APPLICATION NO: 02/2018/0065/ PF

PROPOSAL: Erection of a detached dwelling, alterations to the existing vehicular access and associated works (amended scheme to that previously approved under application code no. 02/2015/0995)

LOCATION: Land at (part garden of) Tan Y Gerddi Mwrog Street Ruthin

ELEVATION PLANS

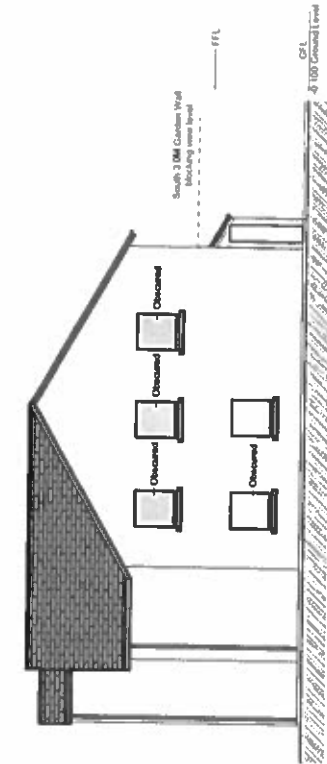
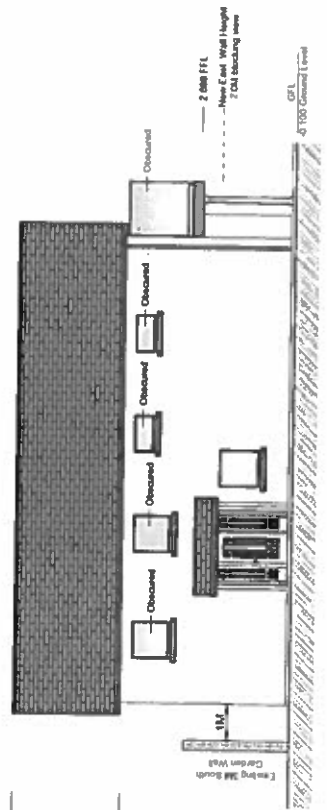
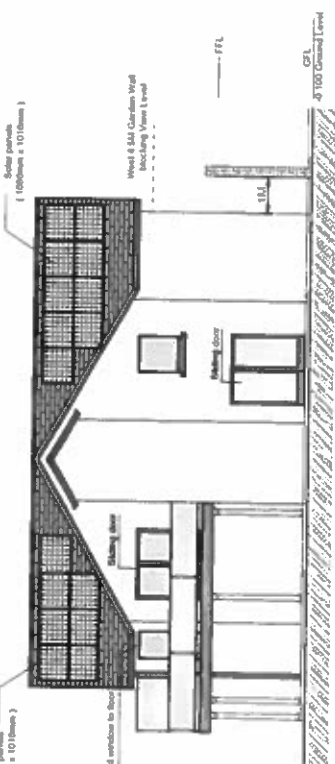
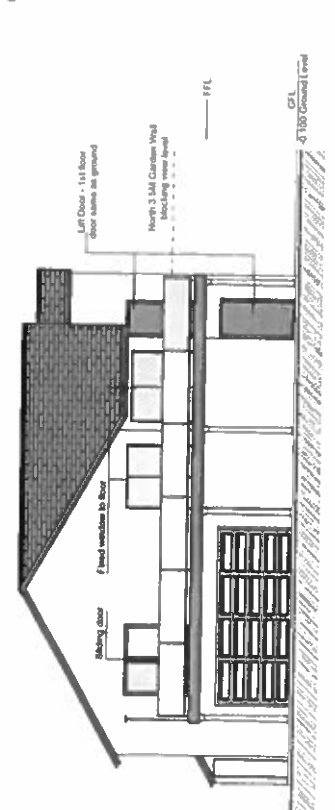
The proposed dwelling would have an eaves height of 4.8m and 7.8m height to the ridge. The height, materials and roof configuration of the proposed dwelling have been amended following the previous refusal and whilst it is acknowledged that the design is somewhat unconventional, having regard to the location of the site set back off the road, the 3m high wall surrounding the site, the mix of property designs and detailing within the area and overall design approach, overall the proposal is considered acceptable. Notwithstanding this, whilst changes have been made to window detailing it is still considered this element is capable of improvement and if a permission is granted, a planning condition is suggested requiring amended window treatment.

In relation to the dwelling located to the south on Mwrog Street; there would be a bedroom window, bathroom and hallway window at first floor level which are all shown to be obscurely glazed, so there is no overlooking potential from these windows. This elevation is located approximately 21m away from the rear elevation of properties in the terrace, which would be in accordance with SPG guidance and having regard to distance, scale and location of windows, it is not considered there would be any overbearing impact on the residents of these properties. It is suggested that the windows be retained with obscure glazing to avoid any overlooking of private garden space.

The balcony on the north elevation would overlook open fields and would have obscurely glazed panels on the eastern corner to ensure there is no loss of privacy for the residents at Tan y Gerddi and therefore would not result in an unacceptable level of overlooking owing to its siting and the screen on the corner.

4. Notwithstanding the submitted plans, the detailing of the proposed windows shall not be as shown, but shall be in accordance with such details as may be submitted to and approved in writing by the Local Planning Authority. The development shall proceed in strict accordance with such approved details.

5. The first floor windows shown on the proposed south and east elevations shall be fitted with obscure glazing, and shall be retained with obscure glazing at all times.
